Product Change Notification

110977 - 00

Change Notification #: 110977 - 00
Change Title: Intel(R) Local Control Panel ASR1625LCP, ASR2600LCP, AXLCPRACK2, PCN 110977-00, Product Design, Product Design, Change Resistance Location On Flex Cable To Improve Display Reliability.
Date of Publication: September 15, 2011

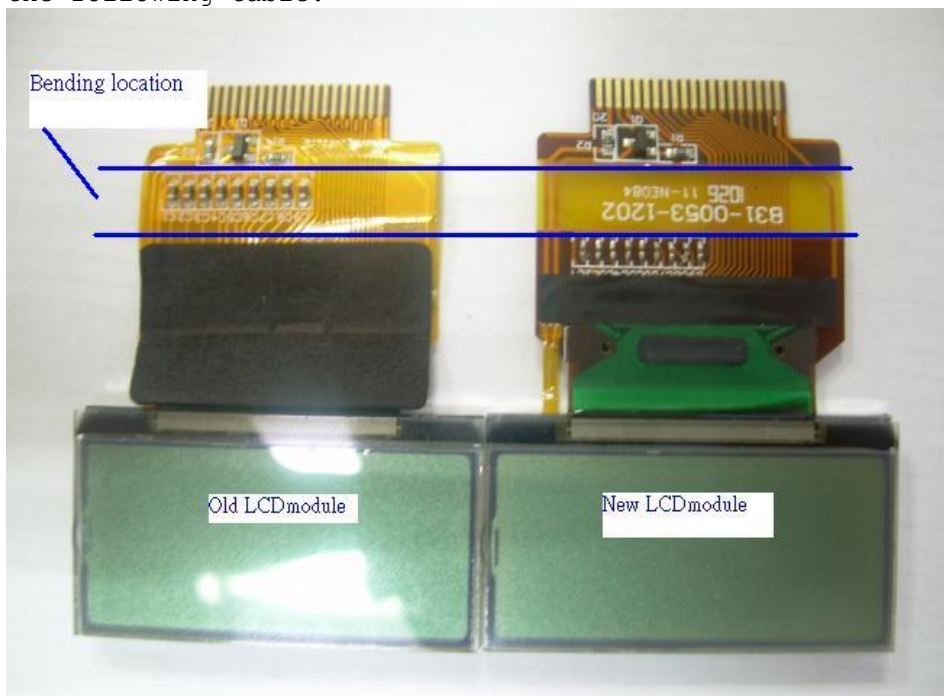
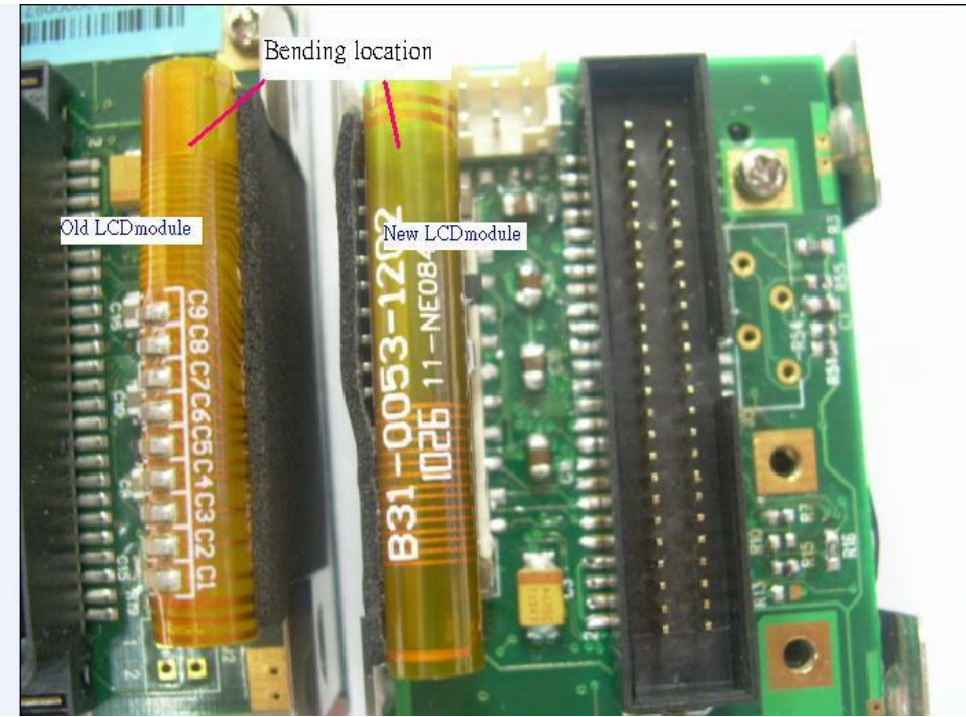
The resistor location on the flex cable of the Intel(R) Local Control Panel ASR1625LCP, ASR2600LCP, and AXLCPRACK2 is being optimized in order to support the large bending angle to improve the flex cable's reliability. Please see the pictures below.
